FPN: 194485-1-52-01 Date: 9/18/2012
 SR 25 (US 27) AMEC RFI No.: A010
 From A Pt. N of W Lake Isis Ave. to the Polk County Line
 Contract No. T1403

REFERENCE: Lighting Plans No. L-37
 DESCRIPTION: Light Poles and Pull Boxes - Slab details

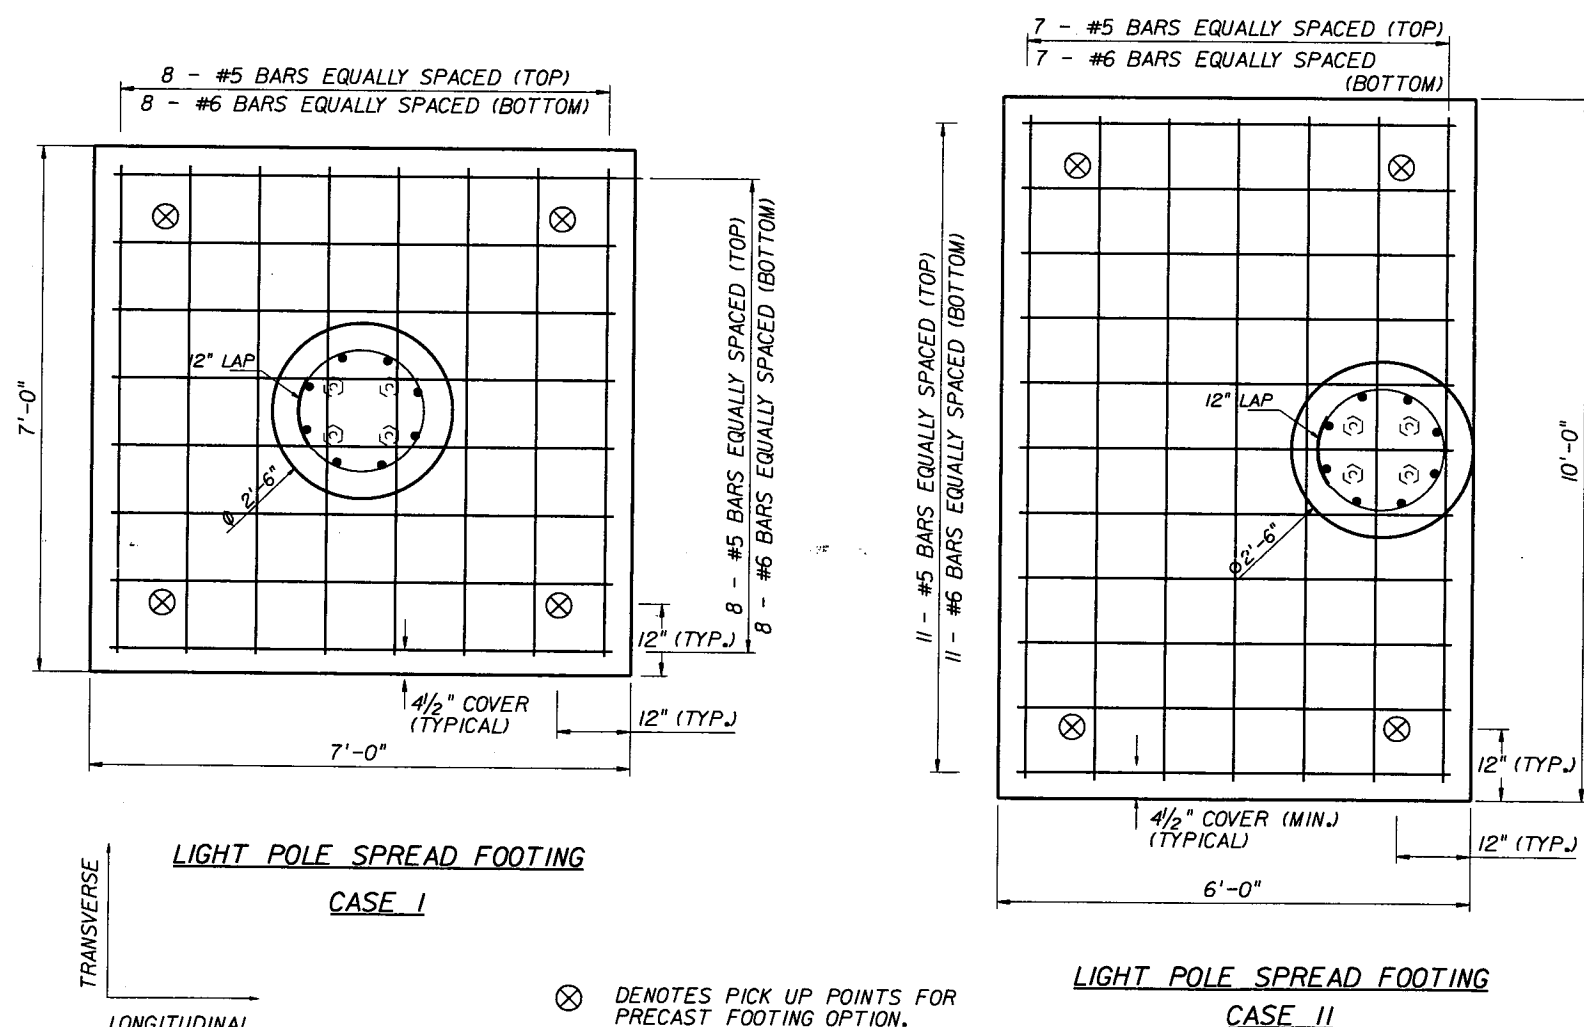
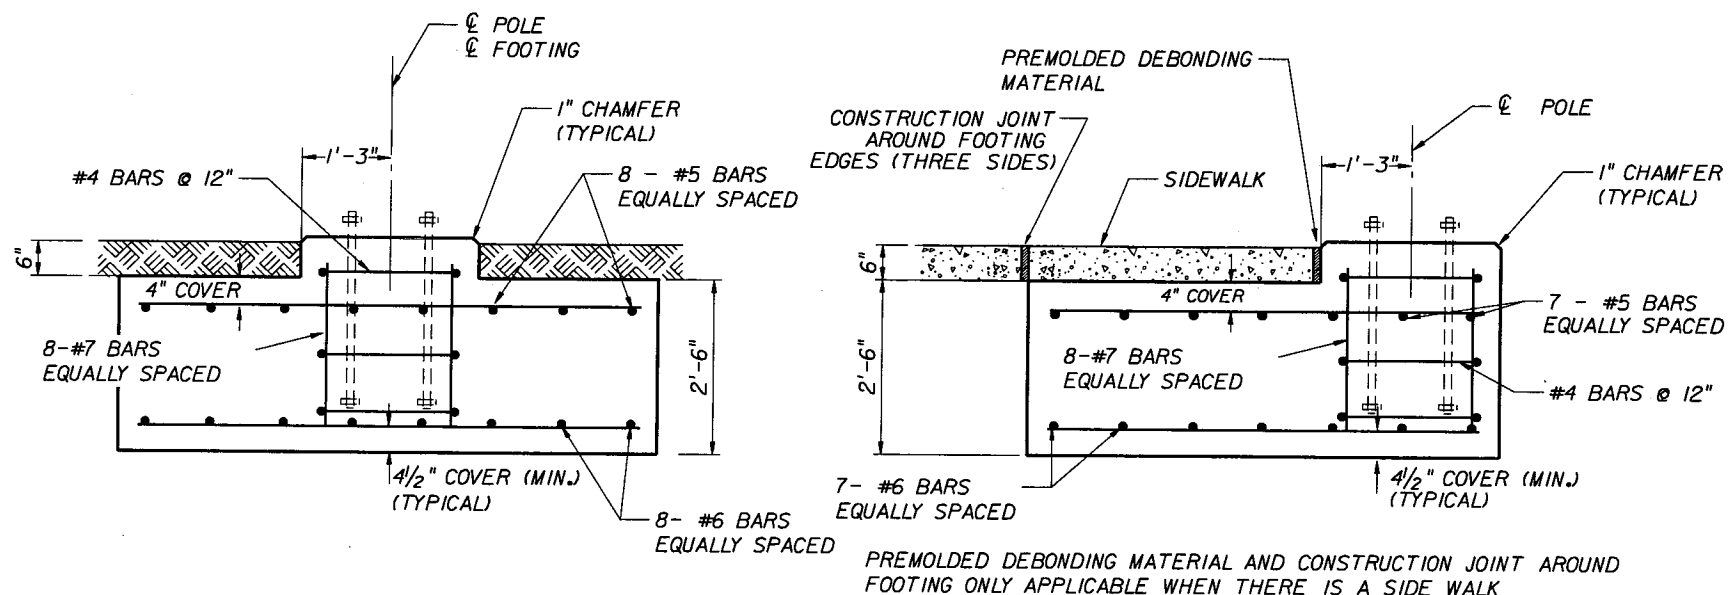
- * As per the plan sheet L-37 the contractor placed the light pole foundations using a spread footer.
- * The plans make reference to Index No. 17503, however that index is not available.

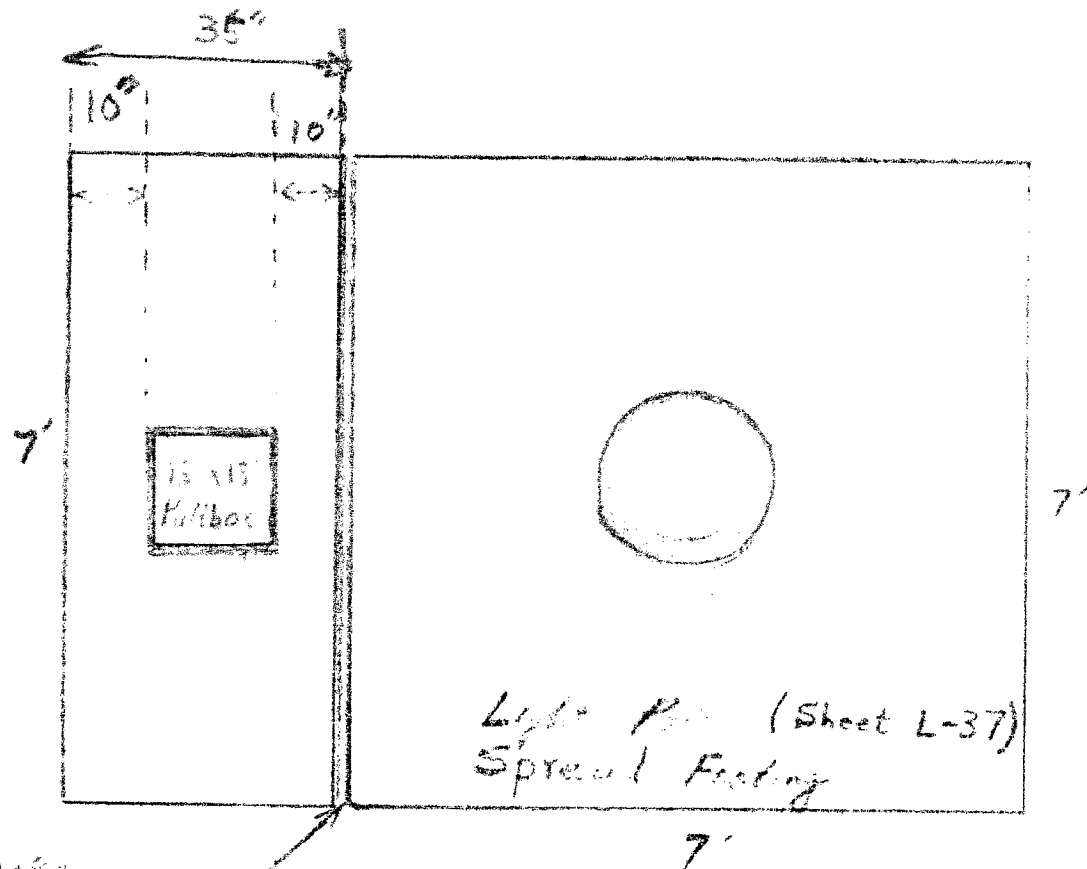
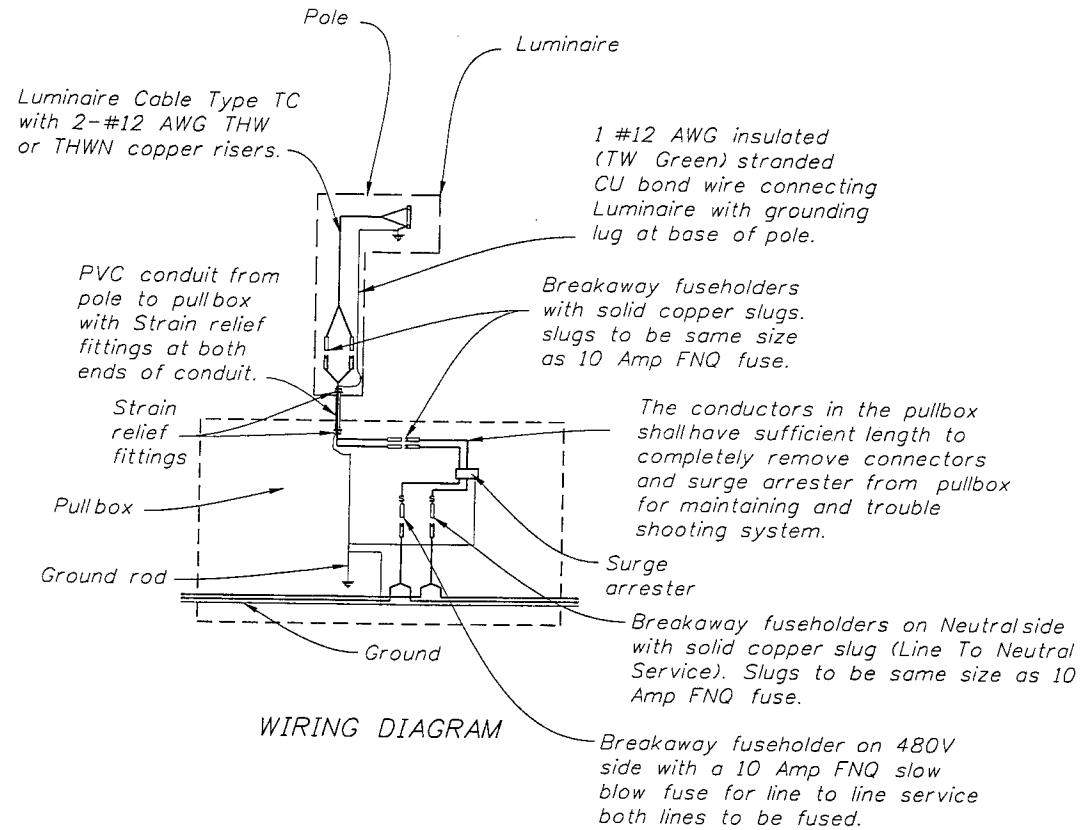
- * As per 2010 Interim Design Standard Index number 17500 (Page 3 of 3) note #6... "Slabs to be placed around all Poles and Pull Boxes in rural locations. In urban areas or where space is limited slab dimensions may be adjusted as shown in the plans." However, the typical section shown in the plans on sheet L-37 do not show a concrete pad around the pole base and does not show the placement of the pull box. If we use the Index Standard it will have to be modified to accommodate the extra width of the spread footer the pull box being placed 1'2" from the pole base and the edge of the footer is 2.25' from the edge of the pole mounting area.

- * Does the Contractor needs to place a concrete pad on top of the footer or just place the pad around the pull box?
- * If so, what are the dimensions?

REPLY:
 See that attached drawings for details on the pull box arrangement with the spread footing option.
